# missouri department of natural resources

This is to acknowledge receipt and approval of revised engineering plans submitted by Paul H. Himebaugh, Consulting Engineer, for the three and one-half acre expansion to the existing permitted sanitary landfill operated by West Lake Landfill, Inc. By this letter we hereby approve operation of the three and one-half acre expansion area under the provisions of the existing sanitary landfill operating permit. This approval is given with the understanding that the landfill will be operated in accordance with the Missouri Solid Waste Rules and Regulations and the engineering design plans dated December 10, 1977.

# West Lake Landfill

REPORT OF APPROVAL OF PLANS AND SPECIFICATIONS  
FOR SOLID WASTE DISPOSAL AREAS  
ST. LOUIS COUNTY, MISSOURI

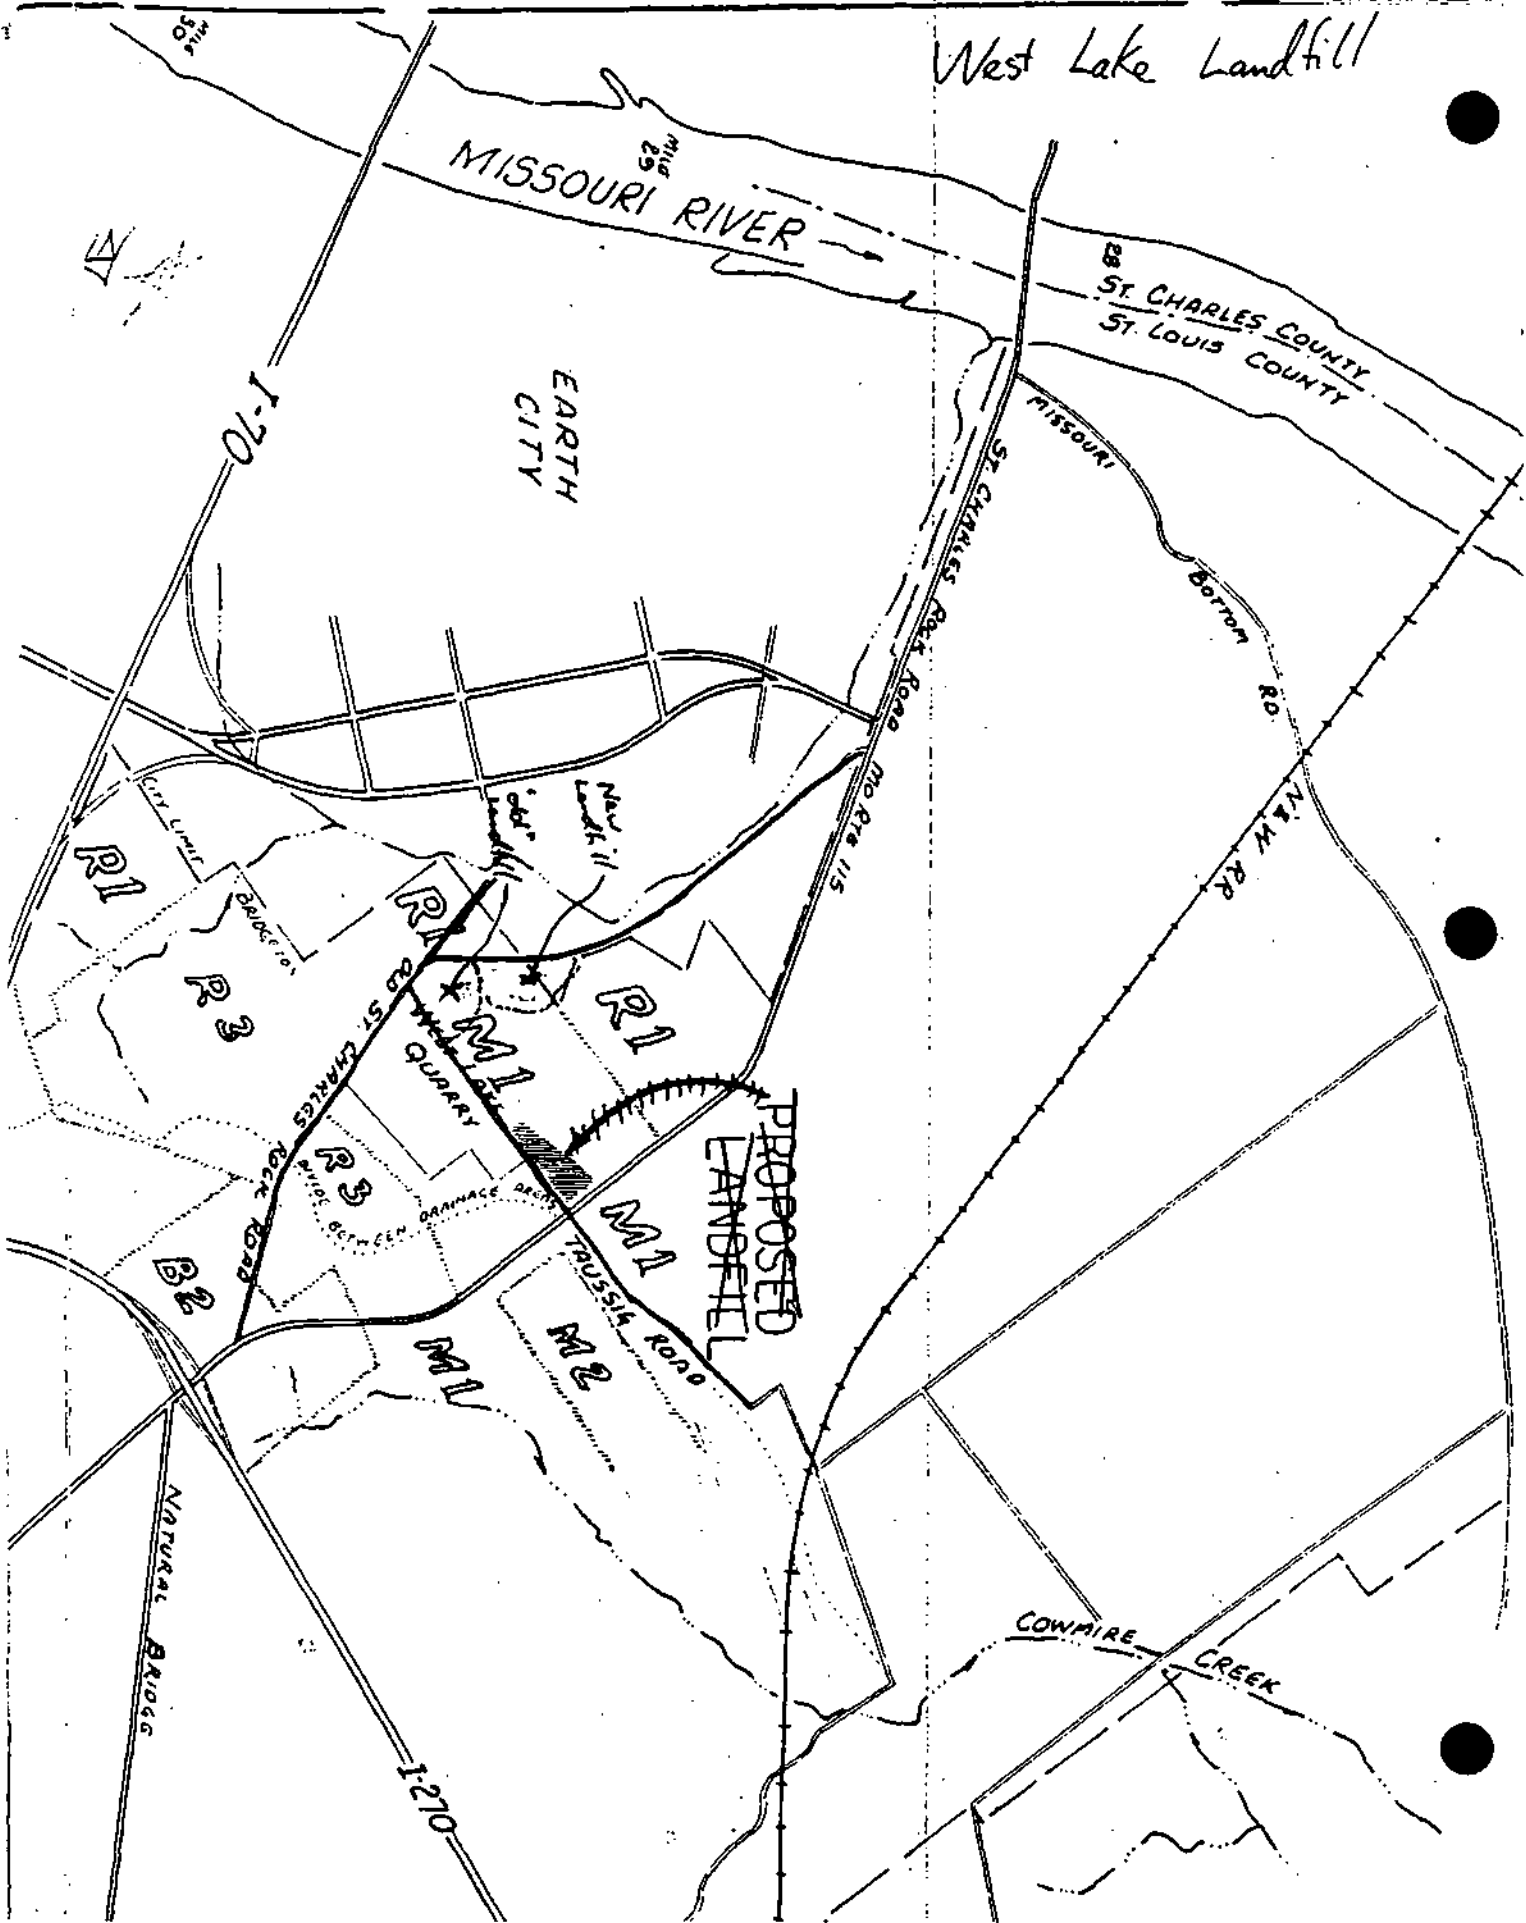
we have no data on groundwater
